OR 140 Corridor Plan

Technical Advisory Committee

Meeting #3 – November 17, 2011

Draft Meeting Notes

Concept I-1: Blackwell Road and Kirtland Road Traffic Signal

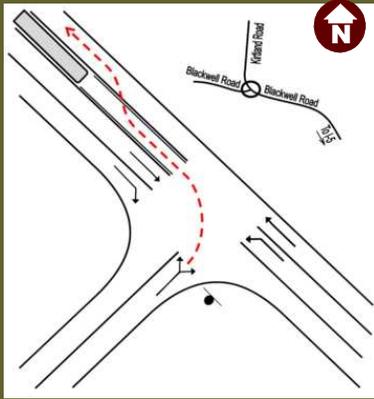
- With respect to Blackwell Road, the members believe it is a good candidate for a 3-lane section, but may want to have ROW for a future 5-lane improvement, if needed, to respond to "shovel ready" needs. The members discussed how the cost opinion was allocated (primarily new structure and ROW), desirable ROW (80 feet versus 100 feet), and design speed (45 mph versus 55 mph). The group debated the merits of using a design speed of 55 mph or reducing impacts by using a lower design speed since the posted speed is 45 mph.

Concept I-2: Kirtland Road Left-Turn Lanes at High Banks Road

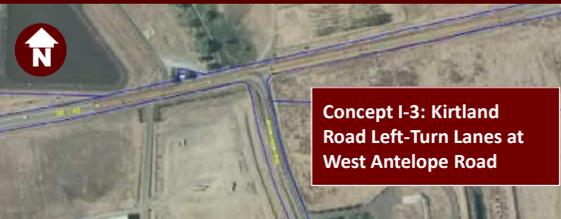
- Recently, development has occurred near High Banks Road including a Ready Mix plant (within the last year) and asphalt plant (within last 6 months). Members expressed agreement with the idea of left-turn lanes at this intersection. They added that Newland is weight restricted by the County. *The consultant team will consider turn lanes (acceleration and deceleration) and/or flashing beacons at High Banks and consider County crash data (to be provided by William Fitzgerald) and potential sight distance issues.*
